HARTLAND TOWNSHIP PLANNING COMMISSION **DRAFT** MEETING MINUTES

# Hartland Township Planning Commission Meeting Agenda Memorandum

**Subject:** Site Plan with Special Land Use Application #22-007 (Automobile wash within completely enclosed building at 10382 Highland Road)

### **Request and Project Summary – Revised Site Plan dated October 6, 2022**

SHEET NUMBER  
C400

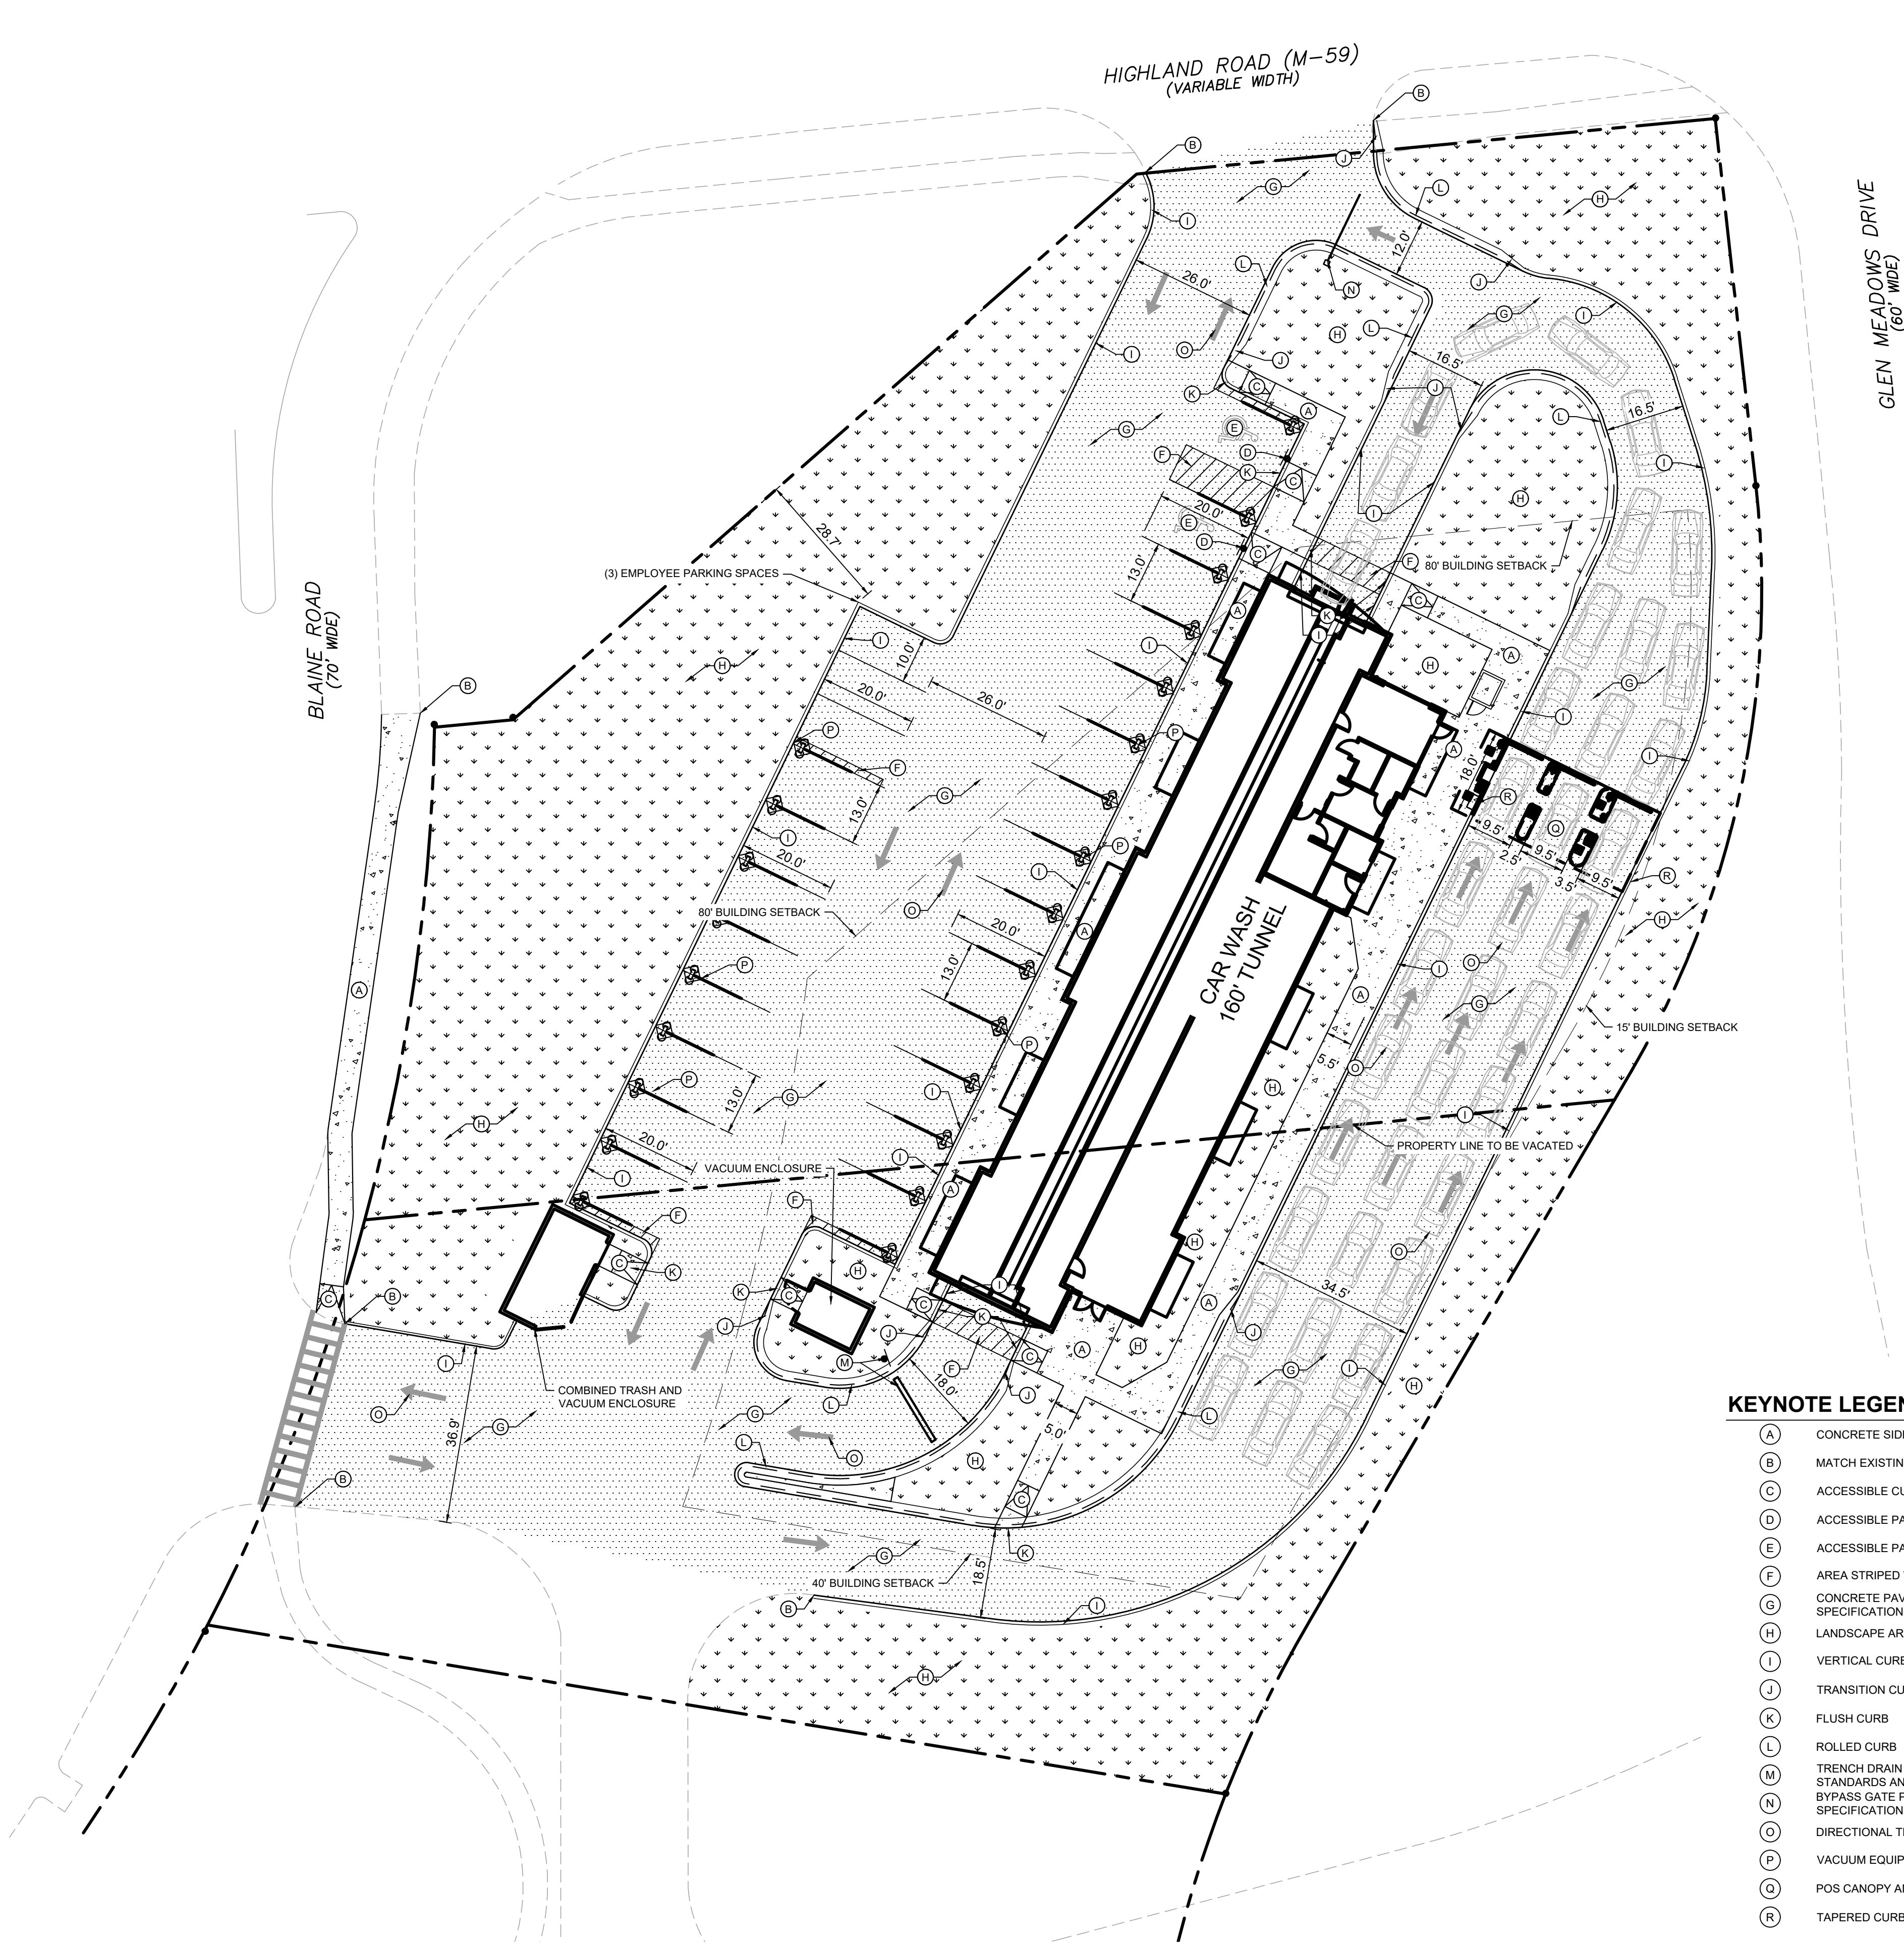
The revised site plan shows the same layout for the building location, building size, vehicular canopy, parking, circulation, and two (2) vacuum enclosures.

Two (2) parking spaces (each with vacuuming equipment) were eliminated along the western row of parking when compared with the site plan dated July 26, 2022. Parking along the west side of the building remains the same as does the 38 stacking spaces on the east side of the building.

1. The Planning Commission will need to make a determination on Section 4.17 of the Zoning Ordinance, which requires that all washing activities shall be carried on within a completely enclosed, roofed building. Vacuuming activities shall be permitted in the side or rear yard only, provided such activities are located at least fifty (50) feet from adjacent residentially zoned property. Entrances and exits shall not face abutting residentially zoned or used property.

*The proposed automobile wash is within a completely enclosed building, with entrances to the site that face Blaine Road or Highland Road. Adjacent properties (south and east) are zoned PD (Planned Development) and residentially zoned properties or uses are farther than fifty (50) feet from the subject site. Vacuuming equipment is in the front yard, which is the area between the leading edge of the building (west elevation) and the right-of-way line of Blaine Road. With regard to the proposed vacuums; at the time the ordinance was drafted, automobile vacuums were designed to contain a tall metal canister style system with a vacuum tube or in some cases, two (2) vacuum tubes. As a result, this older style vacuum system would contain many different tall metal canisters. In general, these were deemed something that would be better served to be screened behind a building. However, the applicant is proposing a different vacuum style system. This system has the mechanical equipment in an enclosure area and the vacuum hoses do not require their own motor or vacuum device. In the proposed vacuum system, no mechanical system is visible. The only item visible is the hoses. Since this is a completely different vacuum system, staff has raised this issue as a matter for the Planning Commission to determine if the proposed design is acceptable. Given the site design, and location on roadways, re-locating the vacuum system to not be in the front yard will create difficulties in traffic flow on this particular site. Essentially, the Planning Commission will have to determine if the vacuum hoses, as proposed would be permitted in the front yard area.*

SHEET NUMBER  
C400

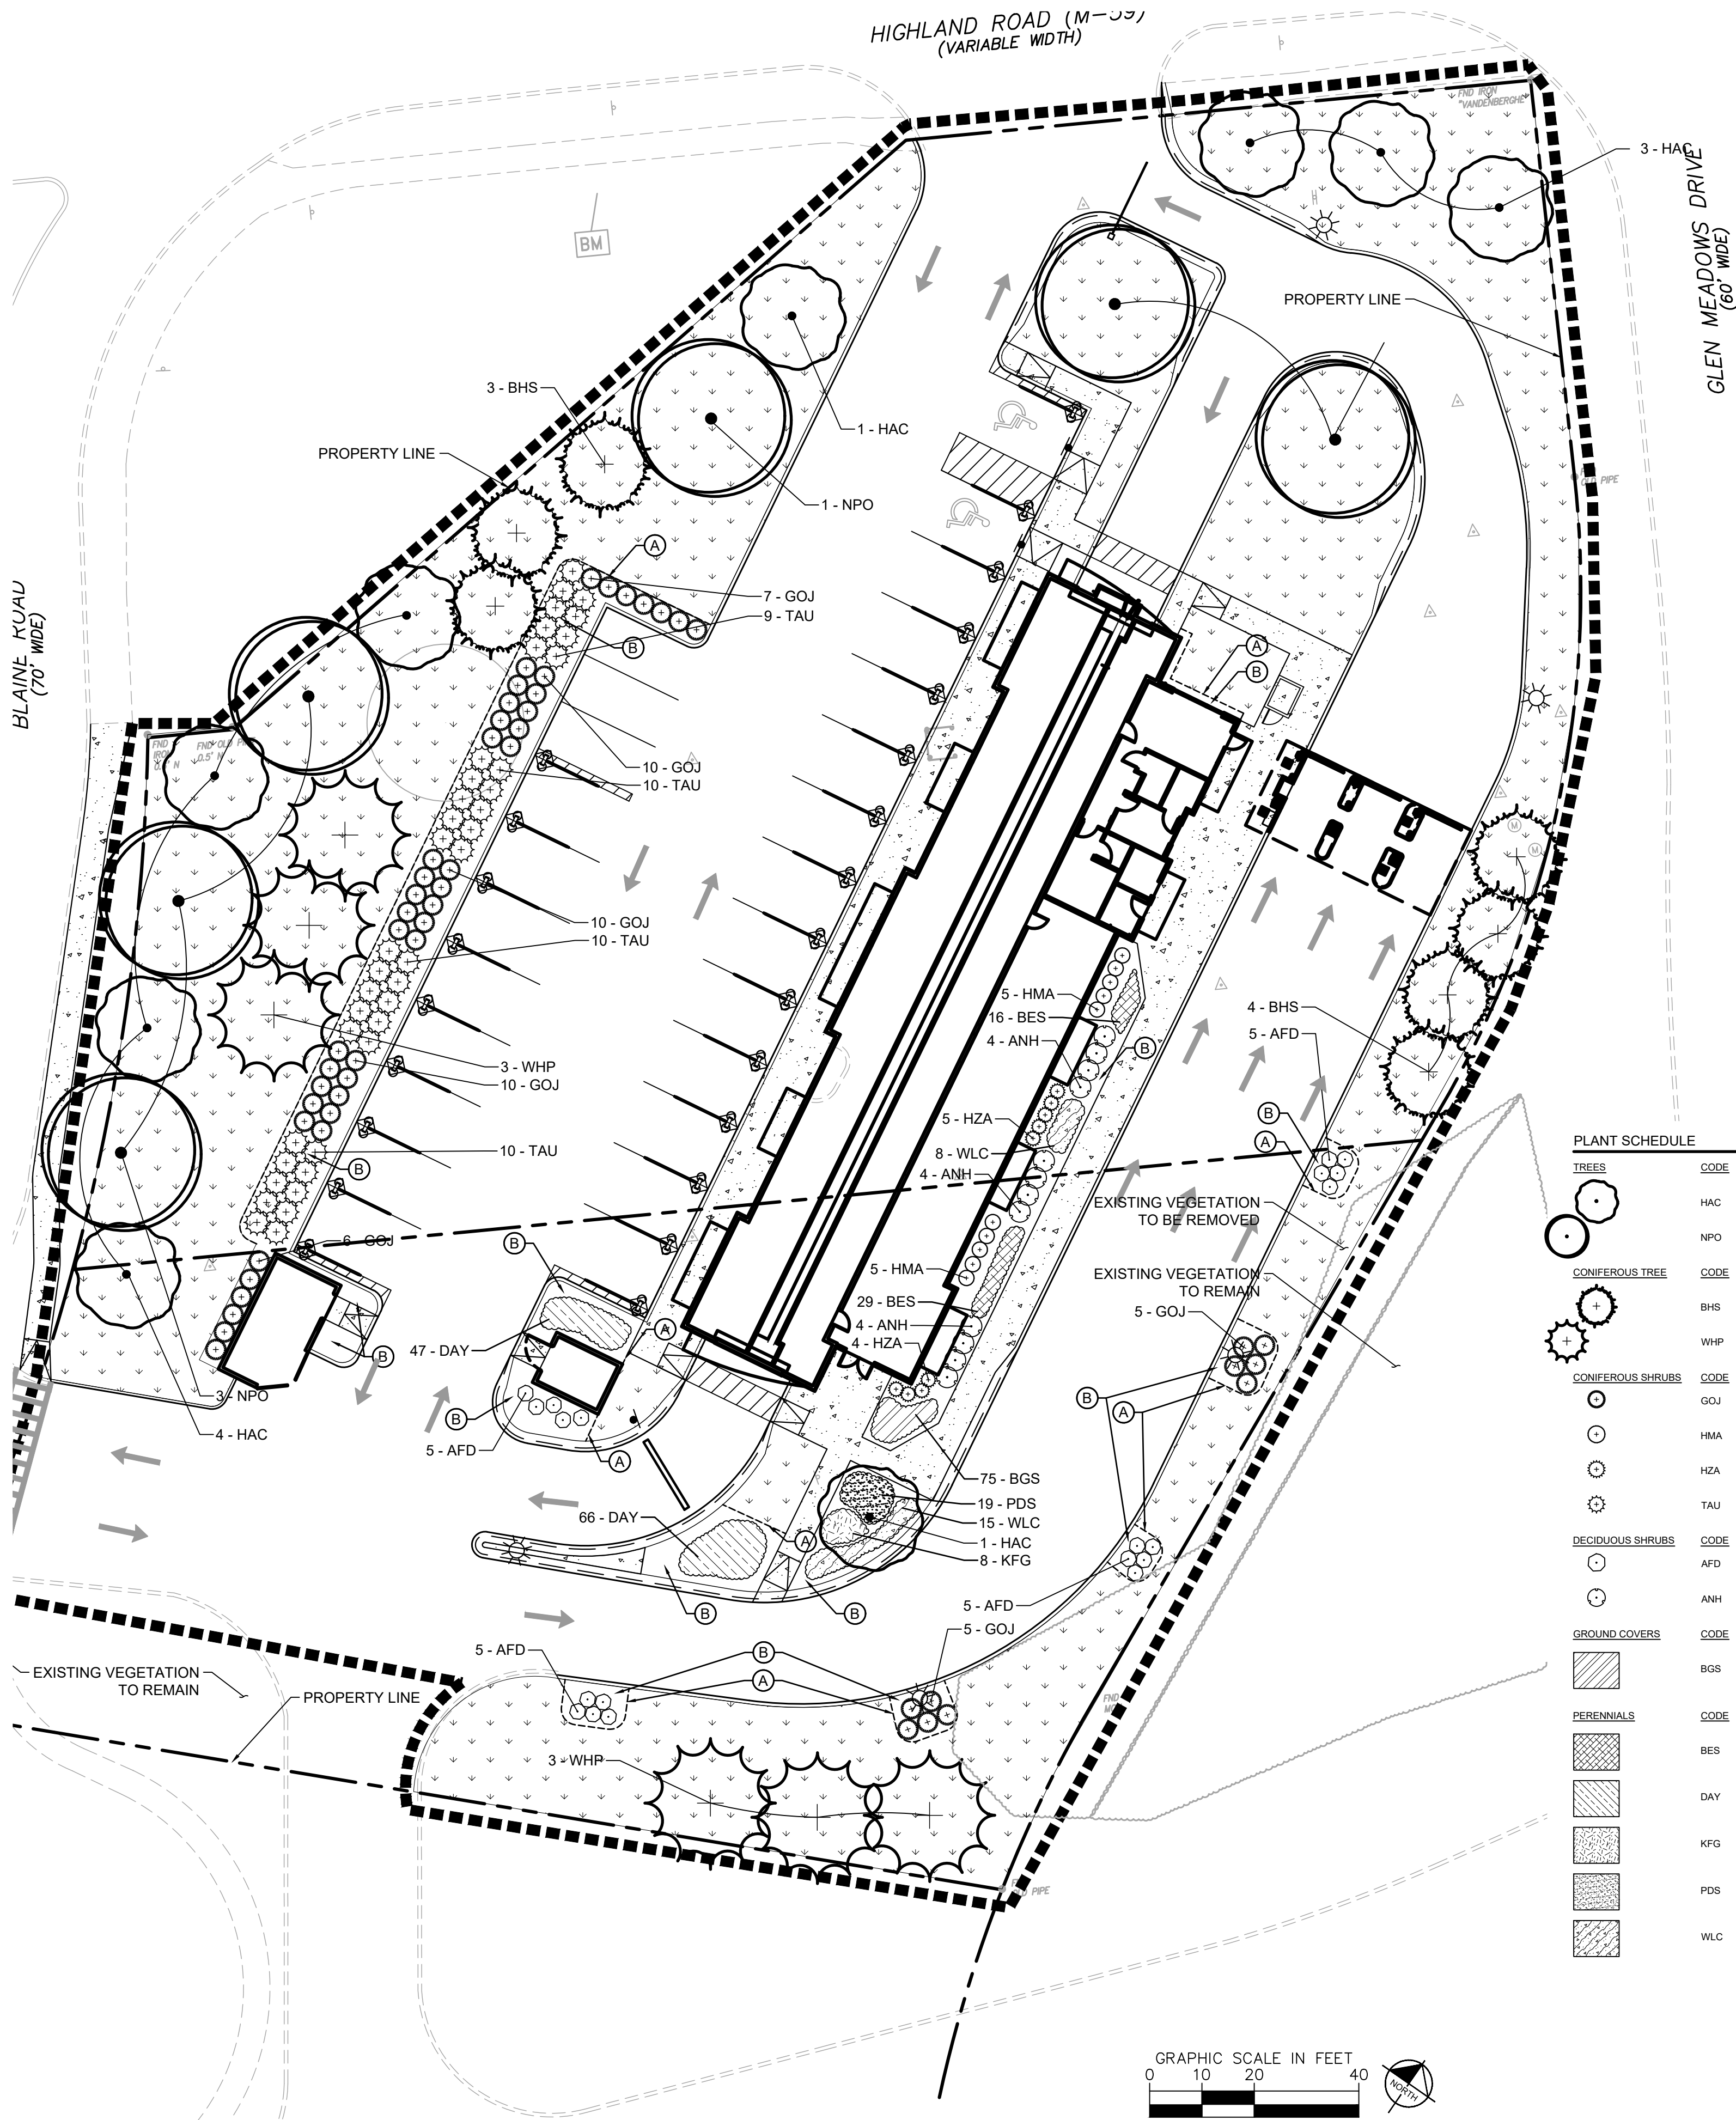
The applicant has submitted a revised landscape plan to address comments at the public hearing on September 8, 2022.

- Required – Landscape berm planted with a combination of evergreen and deciduous shrubs to effectively screen parking lot; or evergreen hedge row a minimum 3 ft. in height; or decorative screen wall
- Proposed – Landscape bed with perennial flowers and ornamental grasses in a planting bed by sidewalk next to parking area.
- Meets Requirement – evergreen hedge row should be added next to barrier-free parking spaces to shield view of parking.
- Comment – Plan to be revised to add evergreen hedgerow on Construction plan set.
